RNTPC Paper No. A/SK-SKT/21C  
for Consideration by the  
Rural and New Town  
Planning Committee  
on 13.12.2019

**APPLICATION NO. A/SK-SKT/21**

**Site** : Various Lots and Adjoining Government Land in D.D. 221, Sha Ha, Sai Kung, New Territories

**Application** : Proposed Comprehensive Residential Development

繪圖  
DRAWING  
A-2

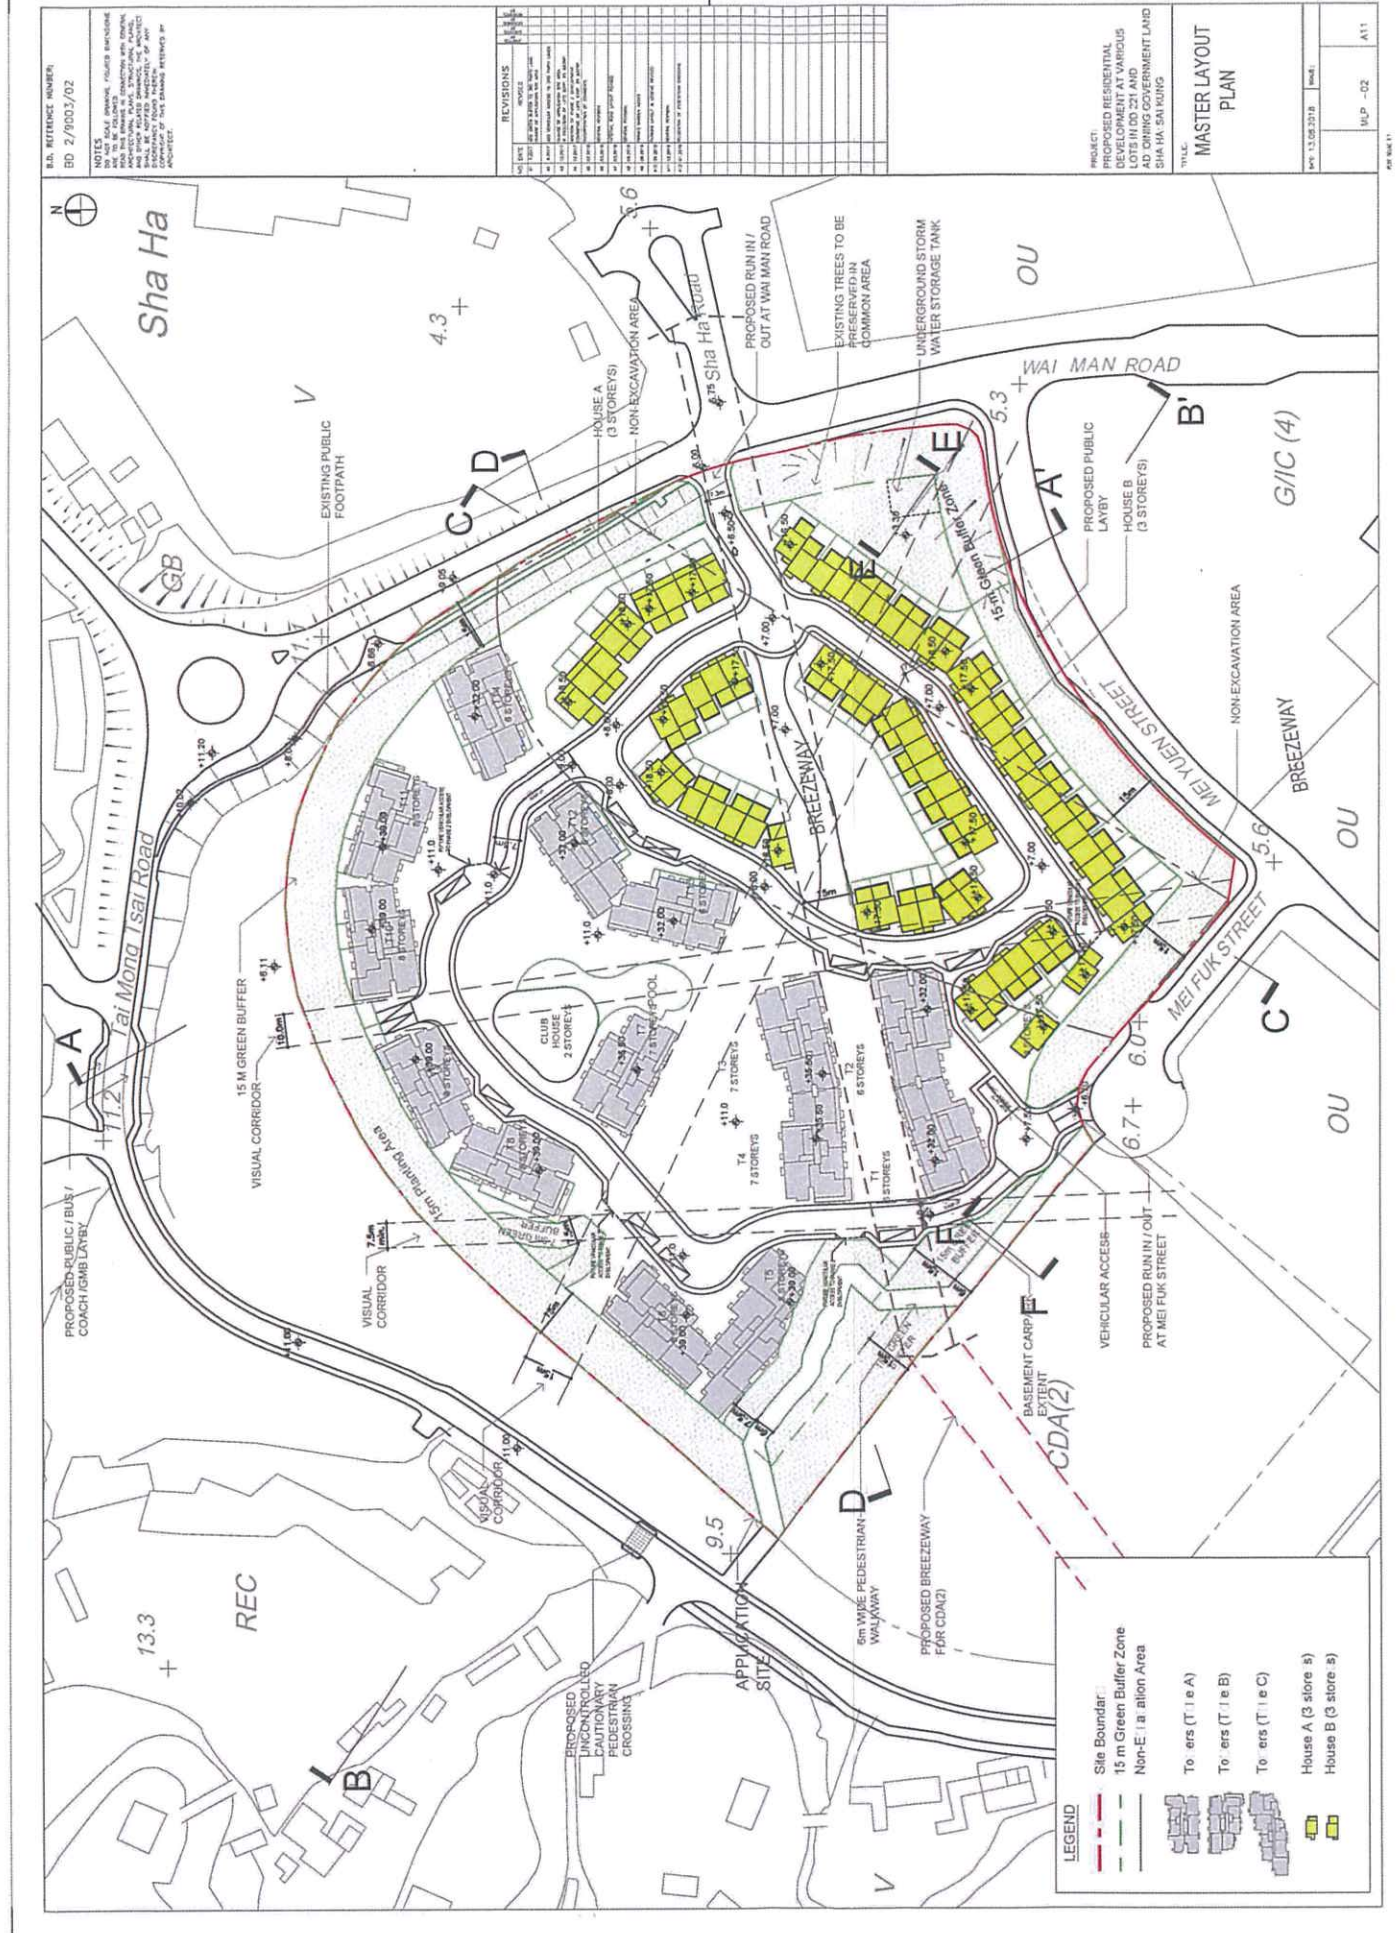
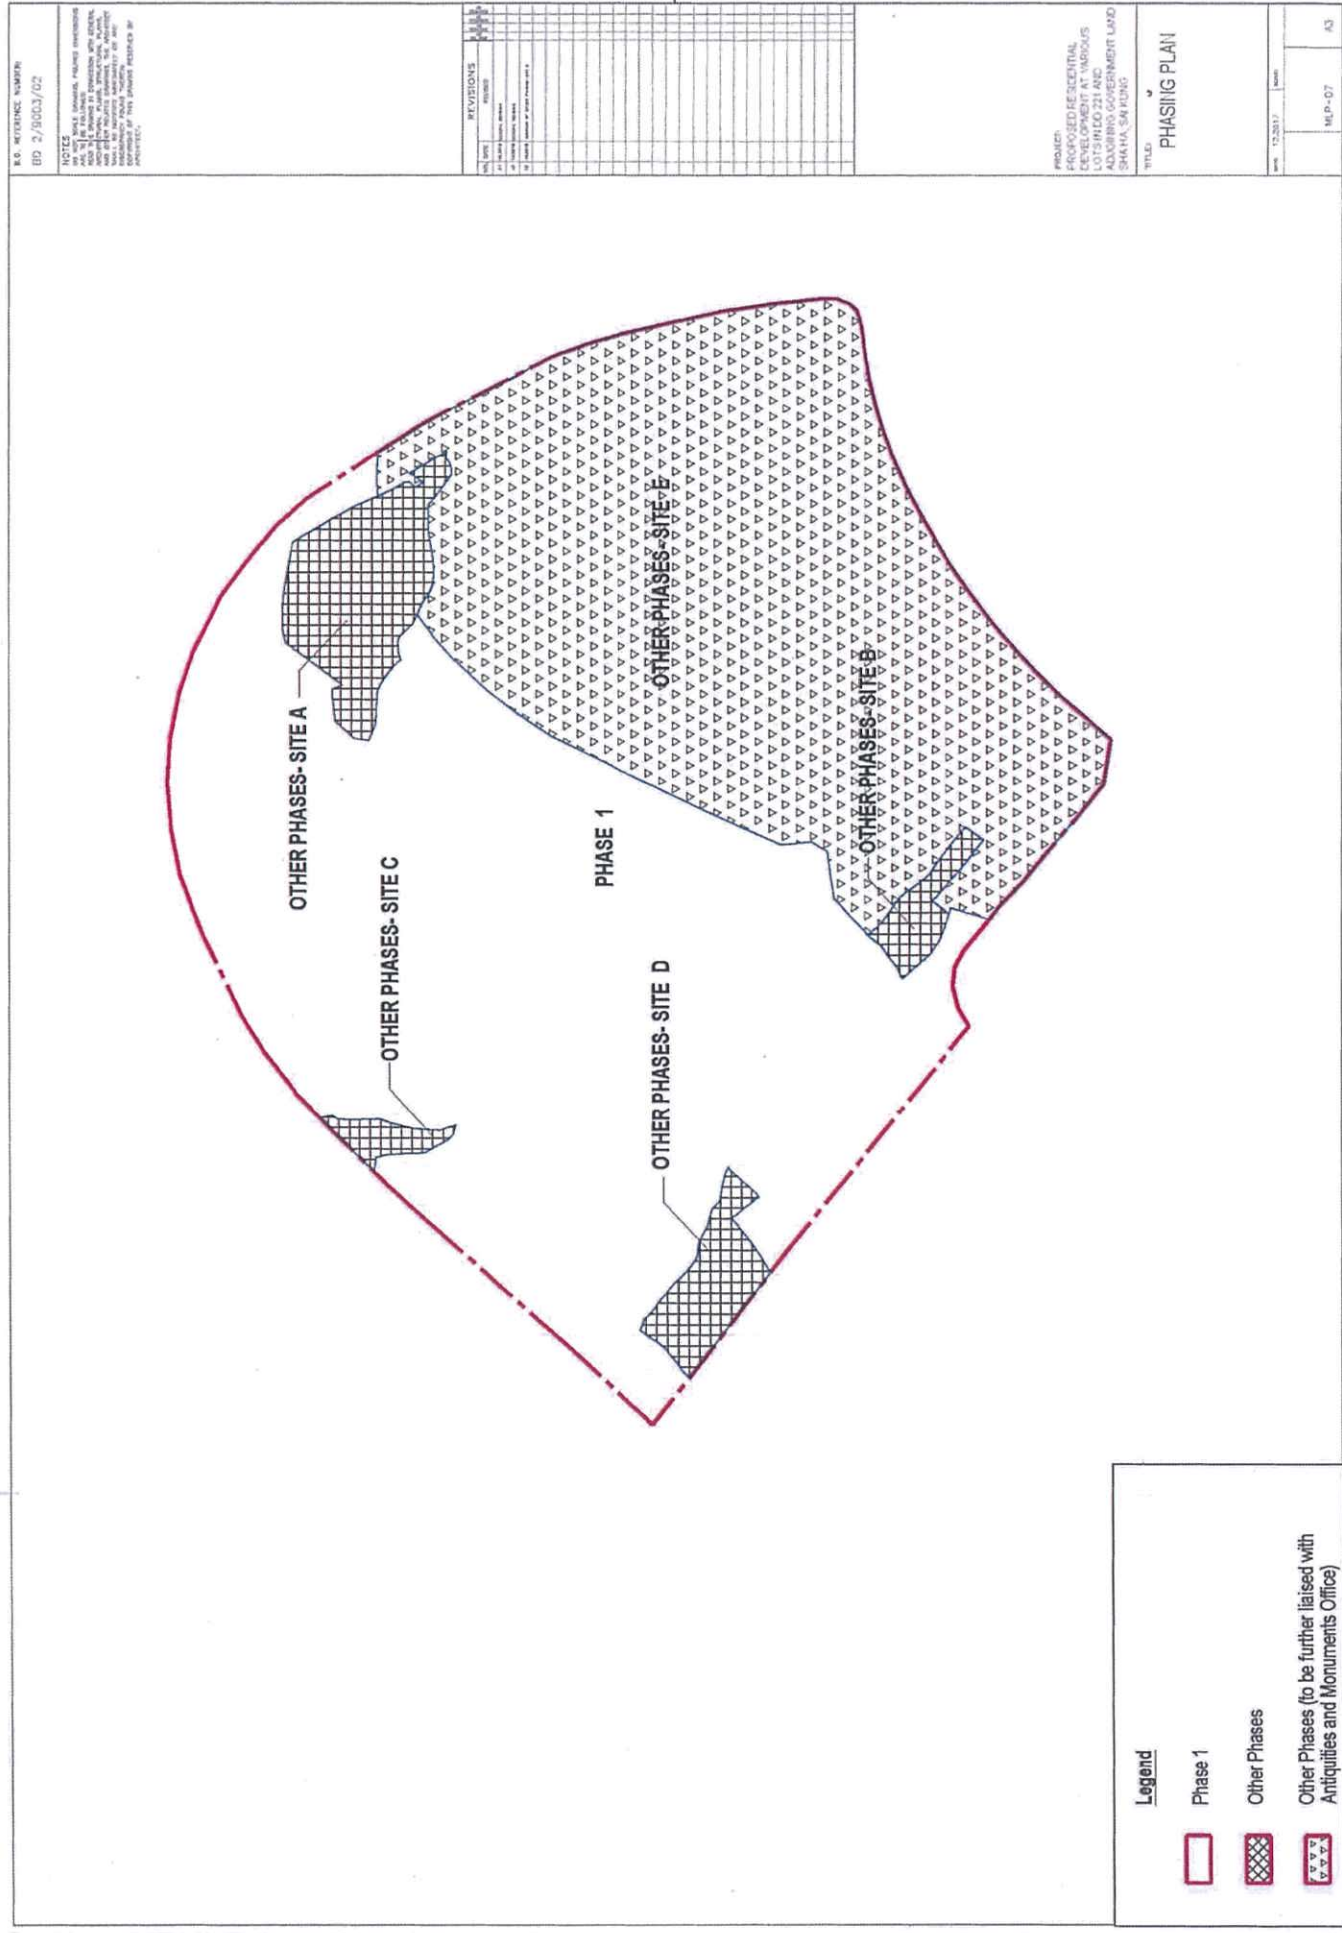
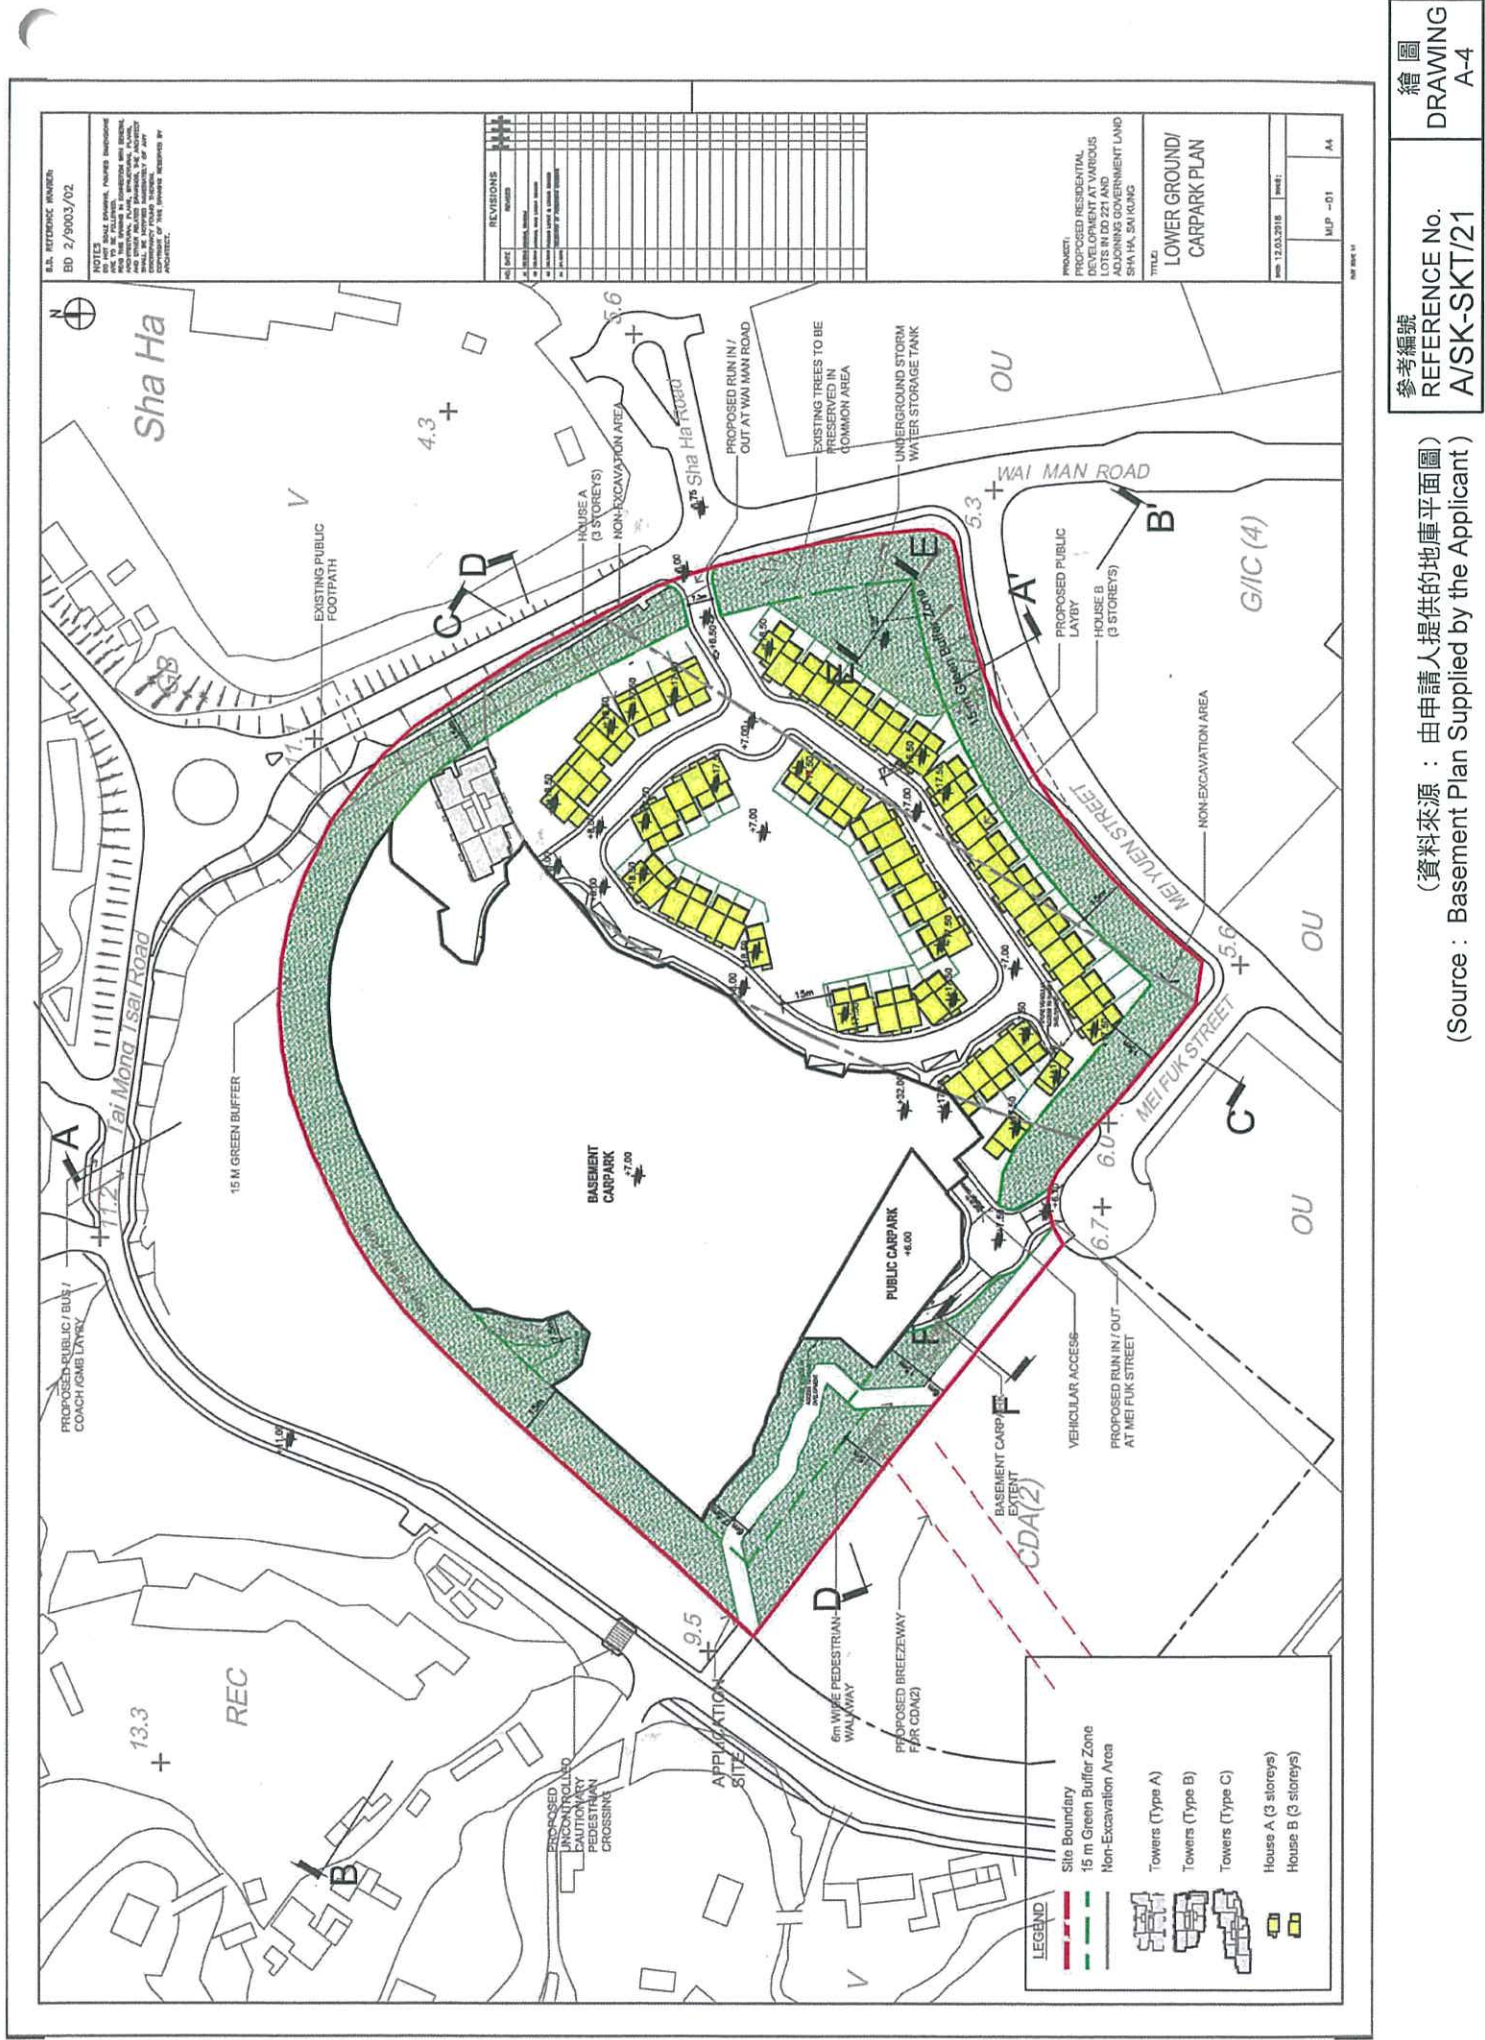
- (b) the Master Layout Plan for the proposed residential development encroaches onto the non-excavation area (NEA) specified in the Planning Brief, the applicants fail to demonstrate that the proposed house development on top of the NEA is implementable and would not have adverse impacts on the Sha Ha Archaeological Site of Interest; and

- (g) according to the MLP (**Drawing A-3**), parts of the footprints of towers in 6-storey and 8-storey high fall within the NEA zone in which its technical assessment of the structural system had not been provided;

- (a) the submission and implementation of a revised Master Layout Plan to take into account conditions (b) to (j) below, to the satisfaction of the Director of Planning or of the Town Planning Board;

Landscape Master Plan  
Dwg. No. : 2011216-NS16-LMP-01

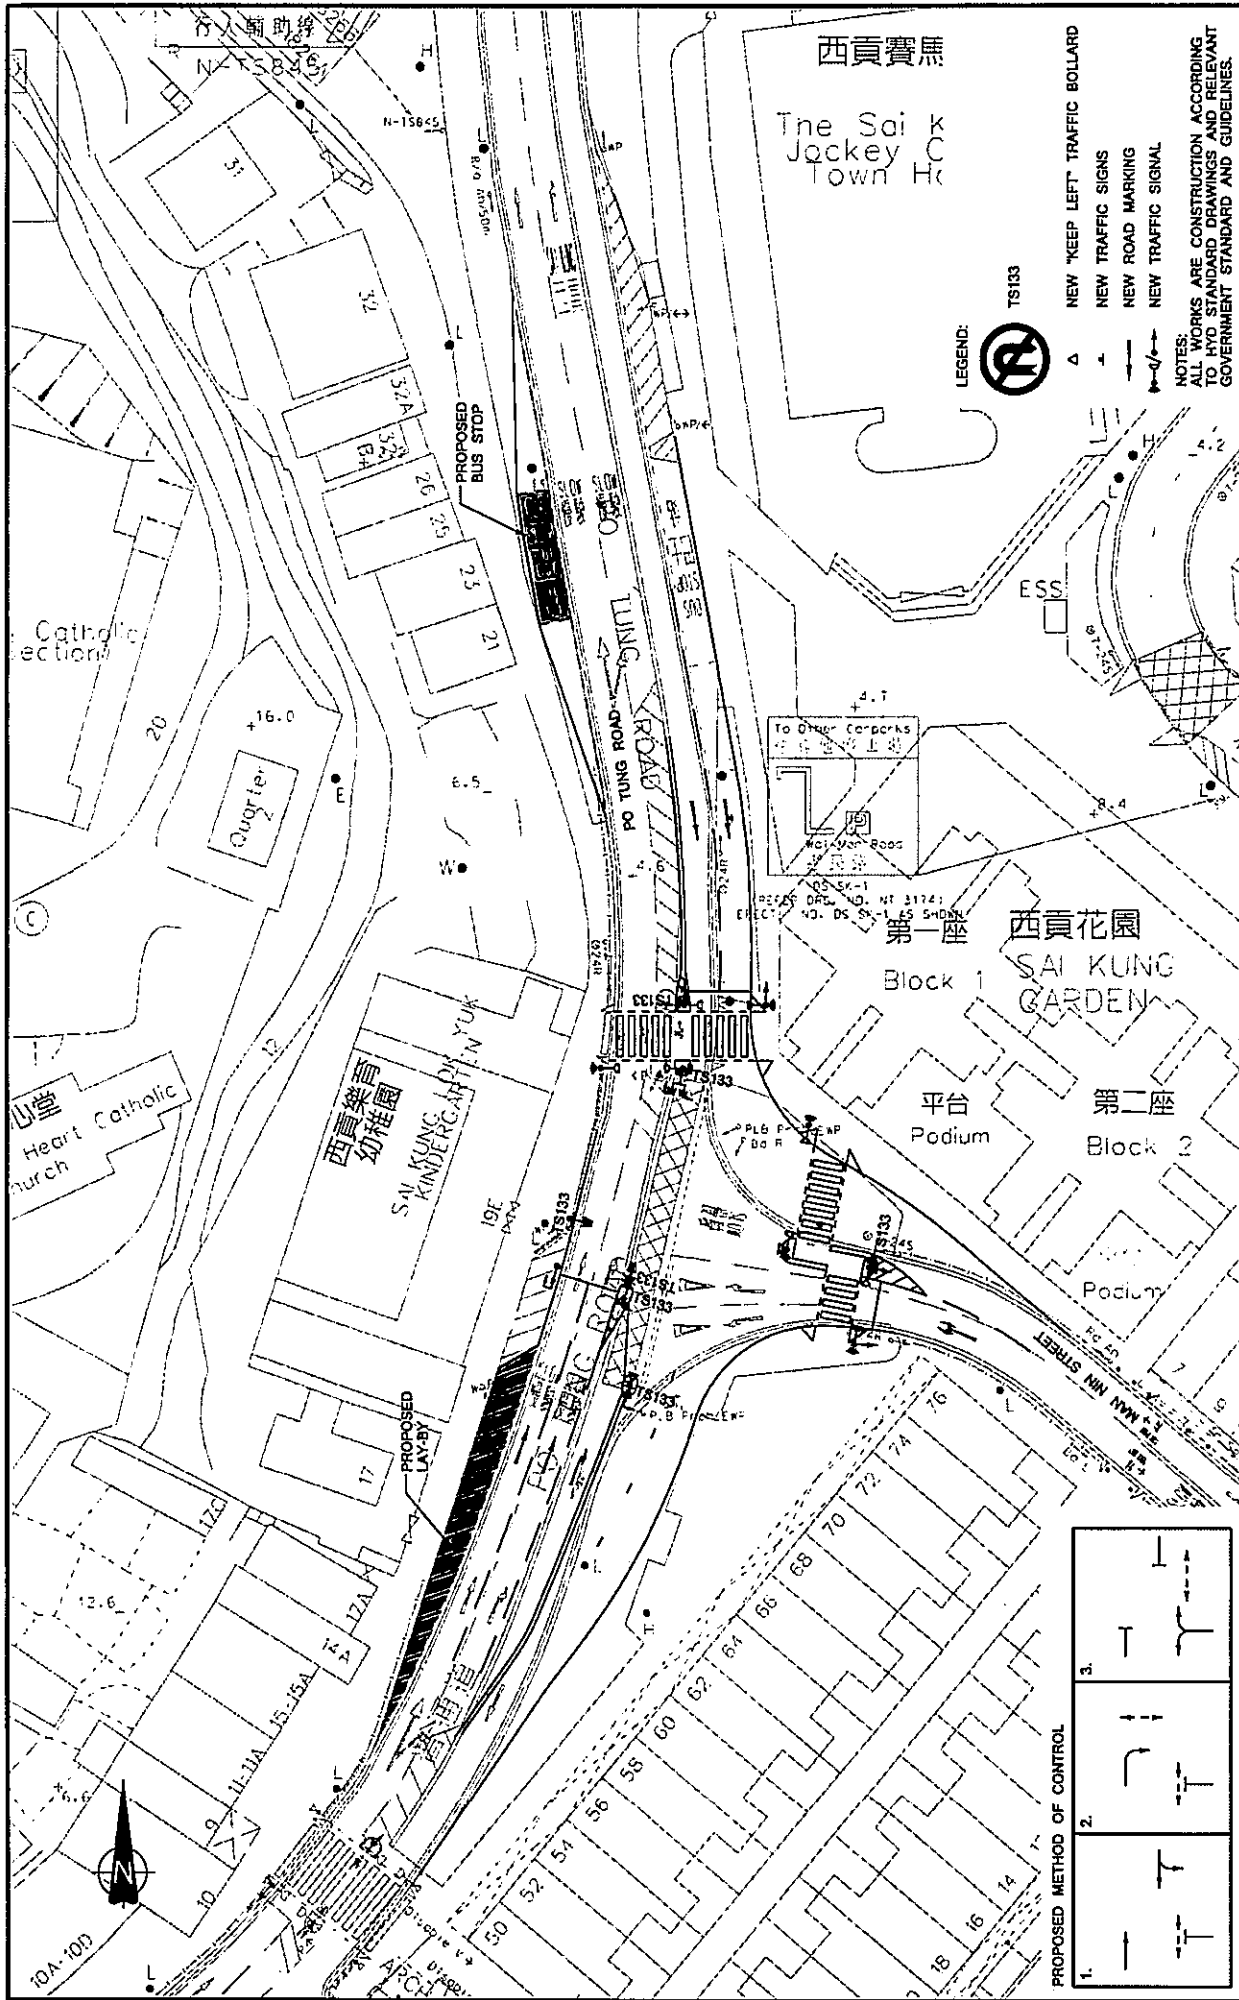
- (a) no objection to the application from the landscape planning perspective;
- (b) according to the tree survey submitted, there are 227 existing trees identified within the site, mainly clustering along the southwestern boundary, while 33 trees are proposed to be retained, including 4 nos. of *Ficus elastica* with diameter at breast height of 900-1500mm. To minimise visual impacts to the surroundings, 15m wide tree buffer

planting of mostly native species is proposed along the Site boundary. Communal open space of about 2,074m<sup>2</sup> is proposed in the middle of the development. The proposed development is generally in-line with the PB;

the submission and implementation of a Landscape Master Plan to the satisfaction of the Director of Planning or of the Town Planning Board
